### **Remarks**

The instant Office Action dated February 7, 2008 listed the following rejections and objections: claims 1-10 stand rejected under U.S.C. § 112(2); and claims 1-10 stand rejected under 35 U.S.C. § 102(e) over Harris *et al.* (U.S. Patent No. 6,696,825); the drawings and the specification are objected to, and claim 1 is objected to.

FIG. 1.

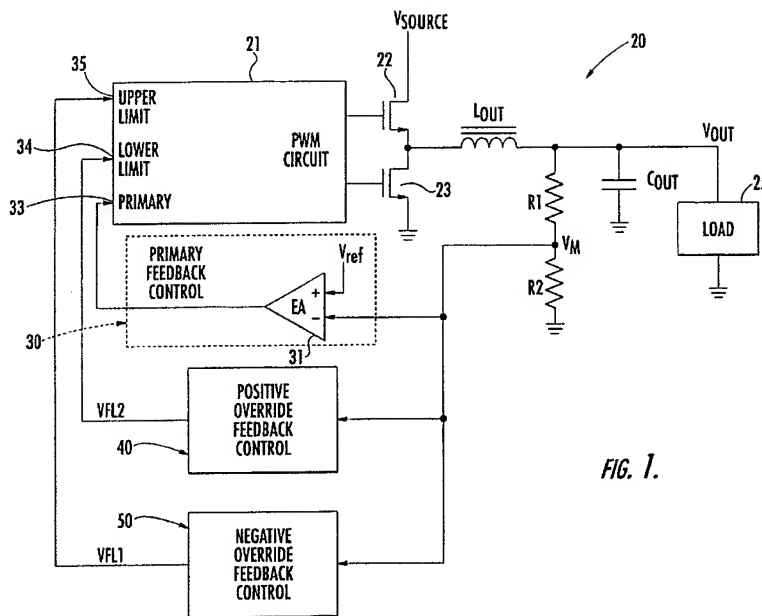
Applicant respectfully traverses the § 102(e) rejection of claims 1-10 because the rejection relies upon the erroneous assertion that Harris’s inductor  $L_{OUT}$  provides energy from  $V_{SOURCE}$  to a parallel arrangement of capacitor  $C_{OUT}$  and the path via power switch 23. As is clearly shown by Harris in Figure 1 reproduced below, inductor  $L_{OUT}$  does not provide energy from  $V_{SOURCE}$  to a parallel arrangement of capacitor  $C_{OUT}$  and the path via power switch 23.

According to M.P.E.P. § 2131, in order to anticipate a claim, the elements of a prior art reference must be arranged as required by the claim. In this instance, the claimed invention requires that the inductor provide the energy from the power supply to a parallel arrangement of the output capacitor and the additional current path. As is clearly shown in Harris's Figure 1, inductor  $L_{OUT}$  (*i.e.*, the Office Action's alleged inductor) does not provide the energy from  $V_{SOURCE}$  to a parallel arrangement of capacitor  $C_{OUT}$  (*i.e.*, the Office Action's alleged output capacitor) and the path via power switch 23. (*i.e.*, the Office Action's alleged additional current path). Instead Harris's power switch 23, along with power switch 22, is used to supply power from a voltage source to load 25 (and capacitor  $C_{OUT}$ ) via inductor  $L_{OUT}$ . *See, e.g.*, Figure 1 and Col. 3:44-57. Thus, the cited portions of the Harris reference are not arranged as required by the claimed invention. Accordingly, the § 102(e) rejection of claims 1-10 is improper and Applicant requests that it be withdrawn.
